REPORT TO BRIERFIELD AND REEDLEY COMMITTEE ON 6TH NOVEMBER 2018

Application Ref: 18/0676/HHO

Proposal: Full: Erection of two-storey extension to side (South), part single, part double storey extension to rear and front canopy (Resubmission).

At: 11a Edge End Avenue, Brierfield

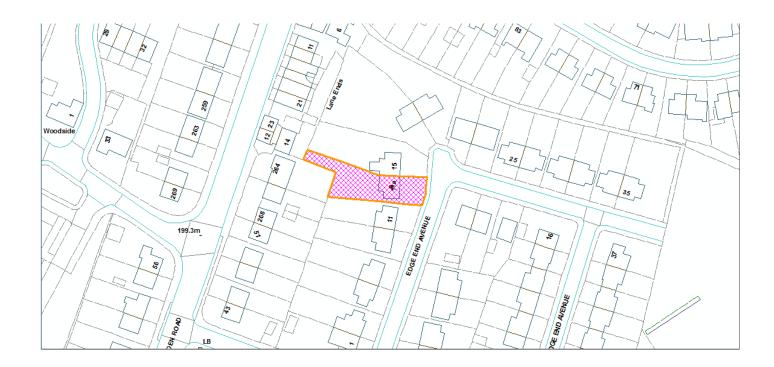
The scheme would however introduce two stories inadequately separated off the shared boundary with 11 Edge End Avenue. The proposed siting and massing of the two-storey side extension would result in severely detrimental impacts on the living environments of the occupiers of adjacent property.

Based on the submitted plans the application is not acceptable however the Applicant has suggested amendments might be forthcoming which may address the concerns raised regarding the impacts on neighbours. These will be provided as part of a Committee Update Report if submitted.
